**Land North of
Meadowbrook,
Burscough**

**Representation to
Yew Tree Farm Draft
Masterplan SPD 2014**

November 2014

Fig 1: Extract of Yew Tree Farm Draft Masterplan September 2014 - Safeguarded Plan

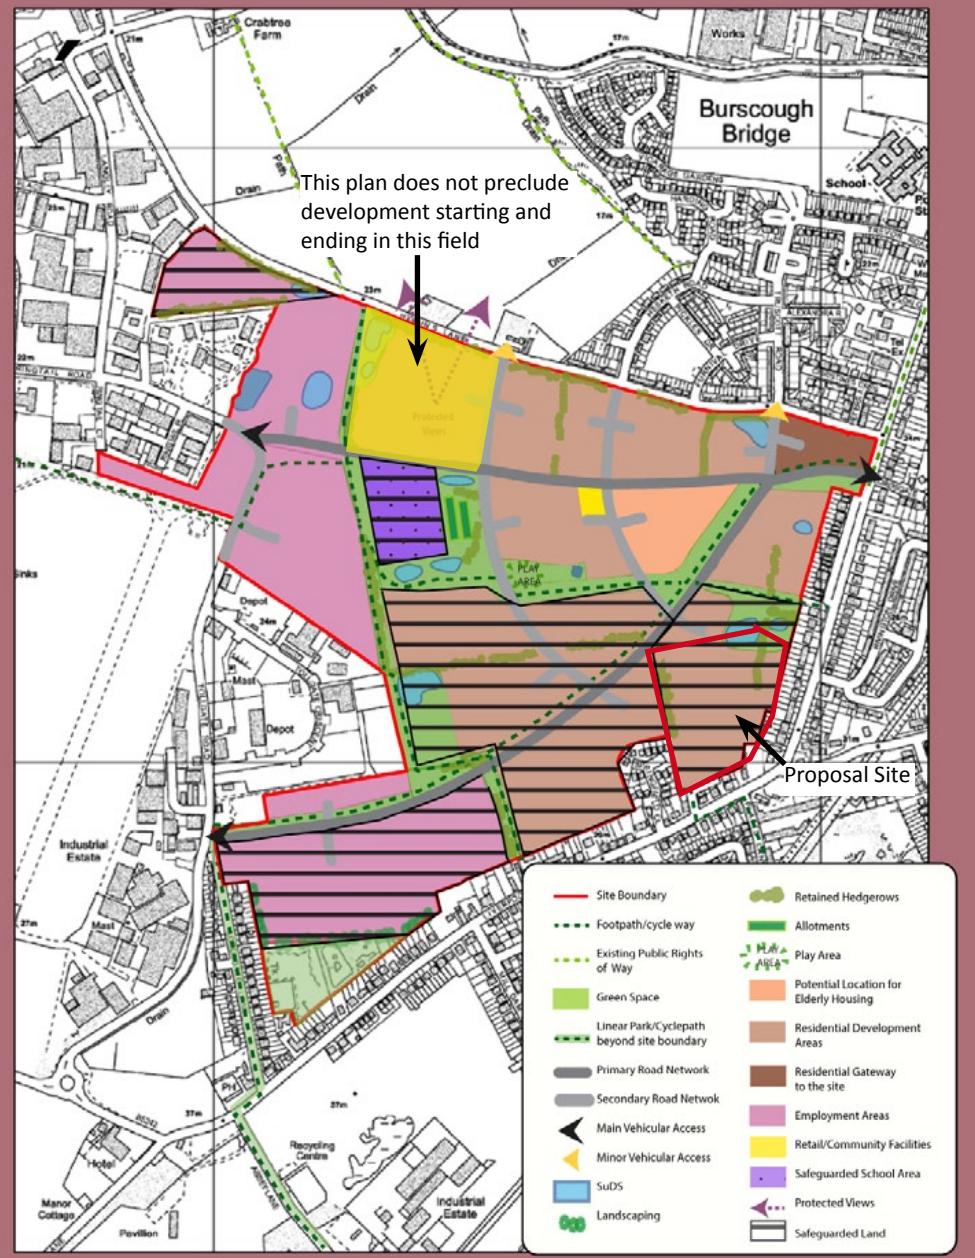
The 'Safeguarded Plan' Figure 1 does not appear to accord with the above objectives for the following reasons:

- 1 The safeguarded plan does not preclude development starting in areas of land which will appear as incongruous isolated development in a predominantly rural location, affecting the public footpaths and general amenity of the area (for example the area marked in yellow on Figure 1, which would also remove the protected views).

- 2 When completed, the first phase development land (ie land not safeguarded) will remove the connection of the remaining agricultural land with the wider rural landscape to the north, remove the protected views, and retain an area of agricultural land which is not connected to a farm, or have any ready access for tractors/ farm vehicles etc. which is neither likely to look or function as agricultural land

Fig 3: Existing landscape and visual considerations

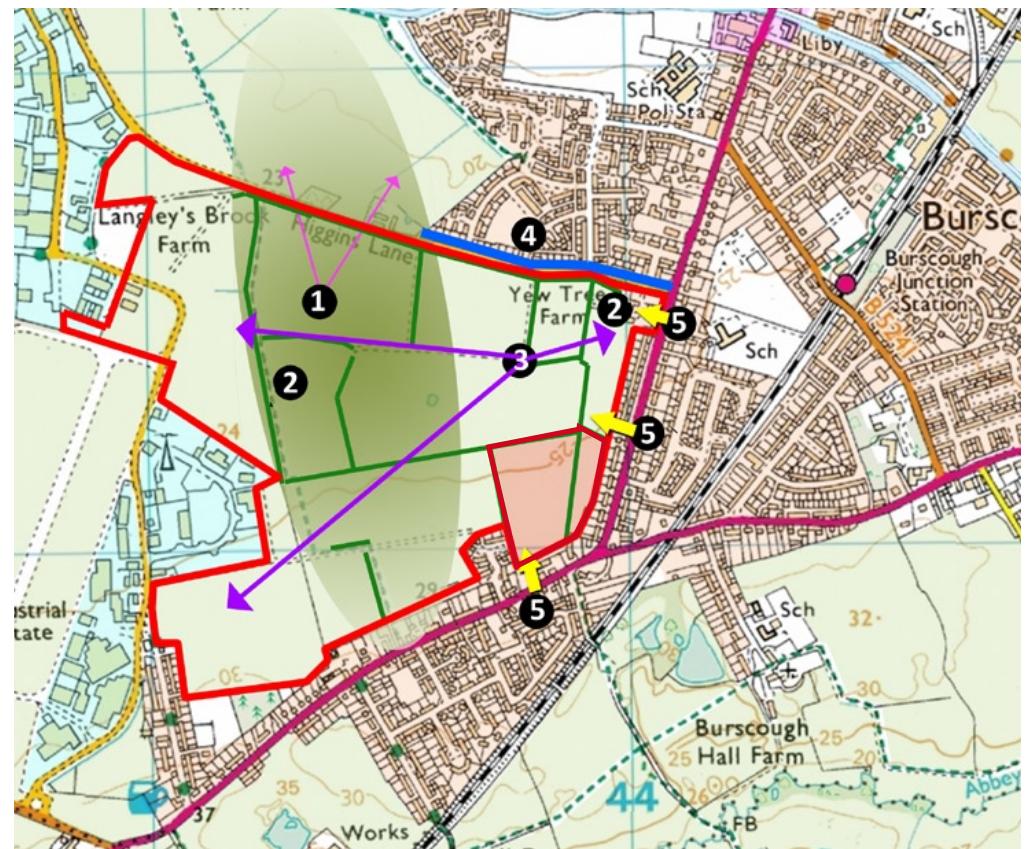
The following points relate to Figure 3 opposite:

- 1 The Draft Masterplan 2014 identifies protected views from the field near footpath accessed to the south of Higgins Lane. The views are across an agricultural landscape to the wider open landscape to the north-east of Burscough.
- 2 This area is identified on the masterplan as the principal access point and a residential gateway site for the proposed masterplan. This would not be prejudiced by phasing of the development in either a north to south direction, or east to west direction.

3 The principle vehicular routes identified within the proposed Draft Masterplan 2014 would require crossing the central open agricultural land in the centre of the masterplan site in order to access western parts of the site, and may need completing in advance of the sites being developed in order to make them accessible to developers. If the site was accessed from various points around the periphery of the site (Liverpool Road South on the east and south, Higgins Lane to the north, and the commercial sites accessed from the east), it would mean that the central agricultural landscape would remain intact for as long as possible, and in perpetuity if this land is not required in the future.

4 Residential properties facing the masterplan site on Higgins Lane currently have open views across the agricultural landscape. Developing the site from north to south will remove these views in their entirety from an early stage. Developing the masterplan site from east to west would preserve the visual amenity of these properties for a longer period, and in perpetuity for some should the entire masterplan area not be required.

Fig 4: Proposed alternative phasing plan

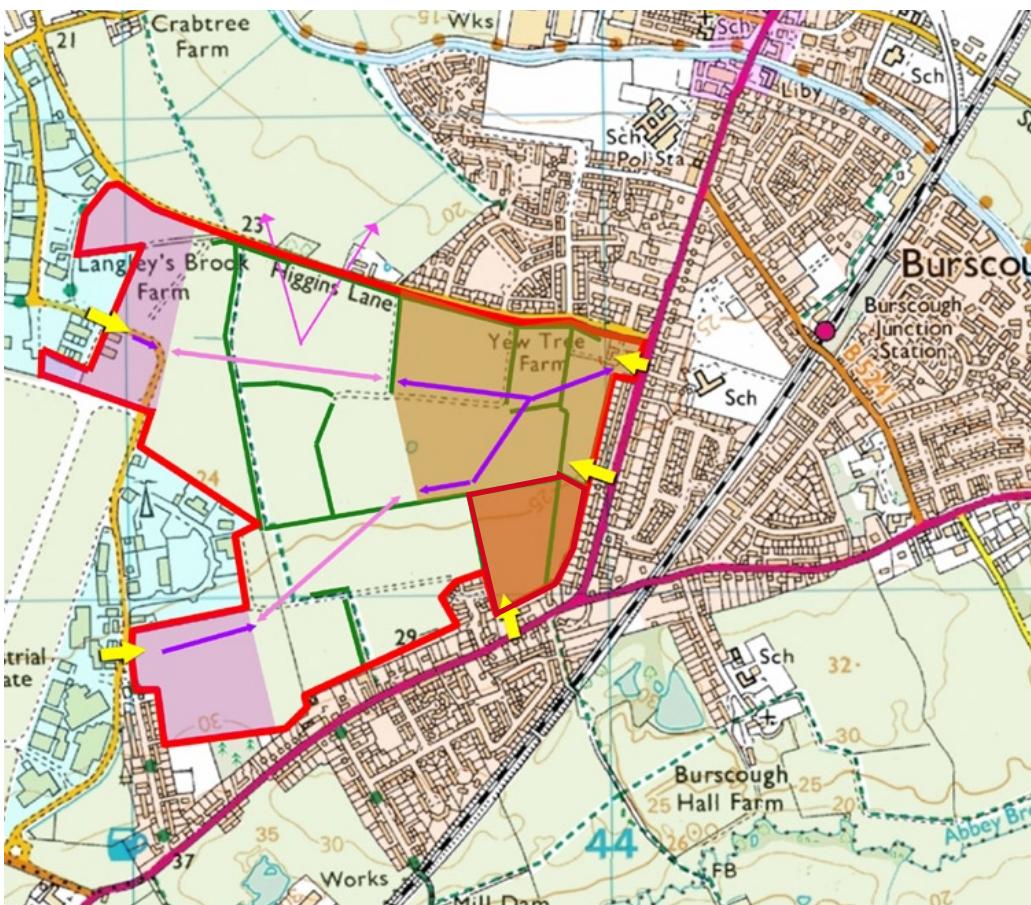
Developing the masterplan as indicated in the adjacent 'Alternative Phasing Plan' (Fig 4) would mean that new residential properties would form a direct urban extension to the properties located to the rear of Liverpool Road South, which have rear boundaries to the existing fields.

This assessment considers that the delivery of the Yew Tree Farm Draft Masterplan SPD Sept 2014 would be a substantially more sustainable development by phasing in an east to west direction, rather than the proposed north to south direction with regard to the following landscape, visual, access, settlement pattern and masterplan delivery considerations.
